Name Of Dam: UPPER BEAVER POND DAM
Location: CHESTERFIELD COUNTY
Inventory Number: VA. 04135

PHASE I INSPECTION REPORT

NATIONAL DAM SAFETY PROGRAM

DEWARD M. MARTIN & ASSOCIATES
WILLIAMSBURG, VIRGINIA
AUGUST, 1979

PLATE 2 N.T.S.

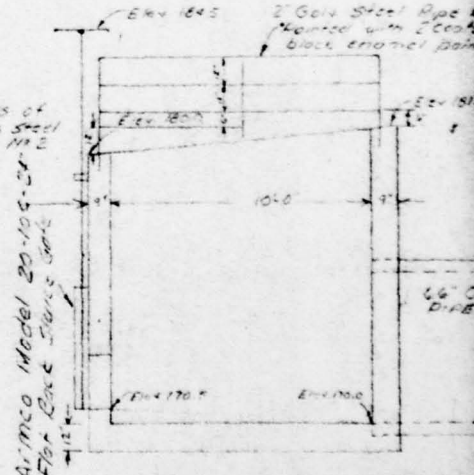
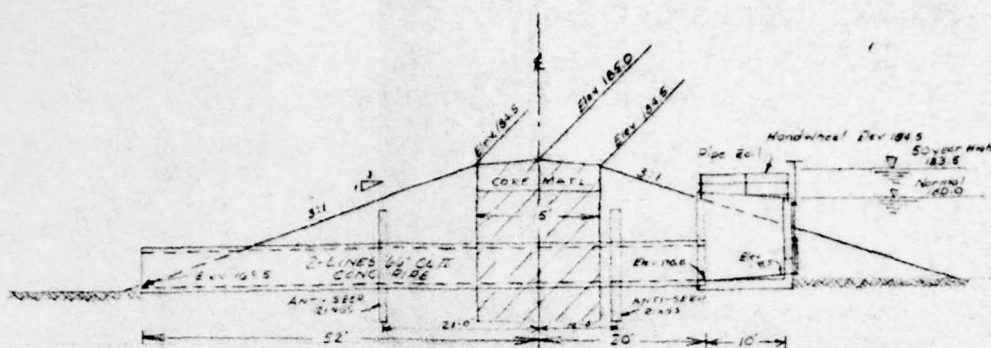
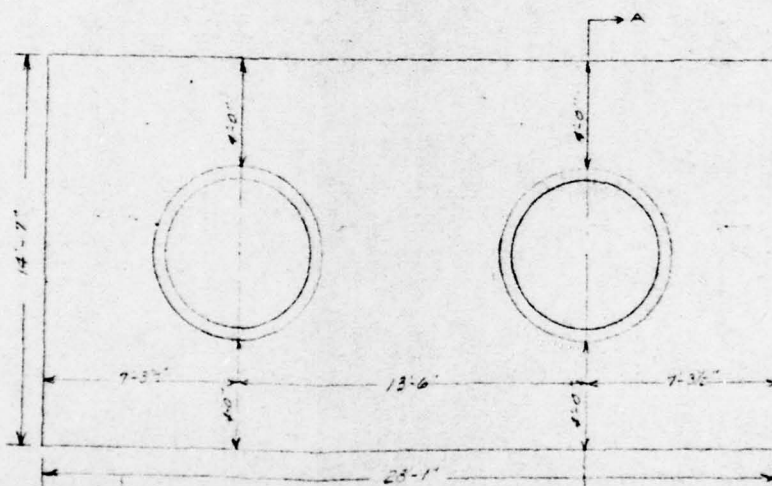
VISUAL EXAMINATION OF	OBSERVATIONS	REMARKS OR RECOMMENDATIONS
CRACKING AND SPALLING OF CONCRETE SURFACES IN OUTLET CONDUIT	None observed.	
INTAKE STRUCTURE	Concrete riser structure 20 feet wide and 10 feet deep. Crest sloped from elevation 180.0 to elevation 181.0. Has 24-inch \emptyset opening at elevation 170.5 to drain lake.	Good condition.
OUTLET STRUCTURE	Two 66-inch \emptyset concrete pipes run from the riser through the dam to the downstream channel.	Good condition.
OUTLET CHANNEL	The outlet channel in the natural streambed of the downstream.	
EMERGENCY GATE	24 inch sluice gate.	Plate 2, Appendix I

VISUAL EXAMINATION OF	OBSERVATIONS	REMARKS OR RECOMMENDATIONS
CONCRETE WEIR	The concrete weir is a 10-foot x 20-foot concrete riser submerged for normal pool elevation. Two 66-inch diameter pipes from the riser run through the dam to downstream.	See Plate 2, Appendix I.
APPROACH CHANNEL	Natural Stream.	
DISCHARGE CHANNEL	Natural stream.	
BRIDGE AND PIERS	None.

PHOTOGRAPH NO. 3
Principal Spillway

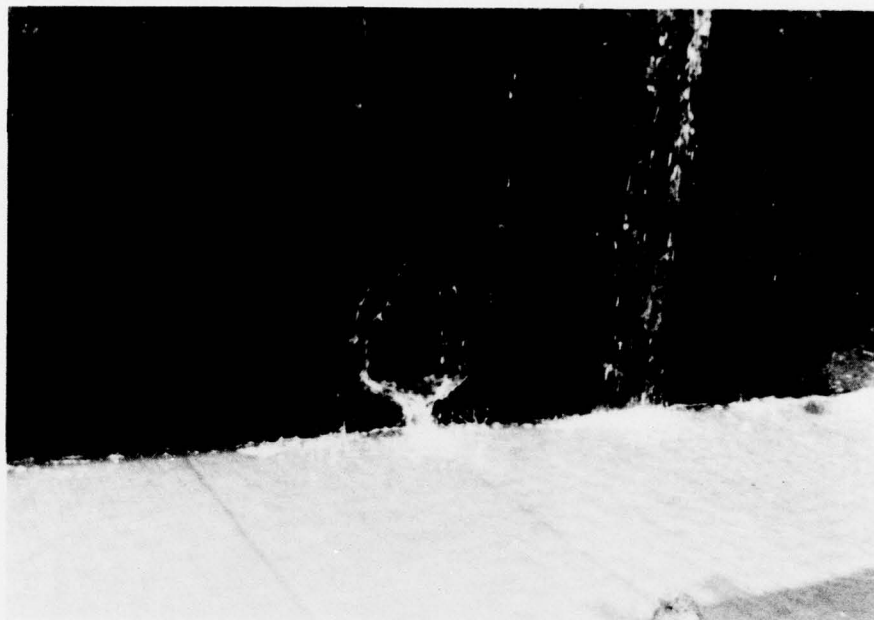
The principal spillway consists of a concrete riser structure 20 feet wide and 10 feet deep. The crest elevation of the spillway is 180.0 at the furthest edge from the dam and is gradually raised to 181.0 at the closest edge to the dam (See Photograph No. 3, Appendix II). Water is carried from the riser structure through the dam to the lower lake by means of two 66-inch diameter concrete pipes. A 24-inch diameter pipe at the base of the riser structure is capable of lowering the reservoir level to elevation 170.5. The emergency spillway is a 100-foot wide V-shaped grass channel with a crest elevation of 184.0. The sides of the emergency spillway channel have slopes of 50(H):1(V).
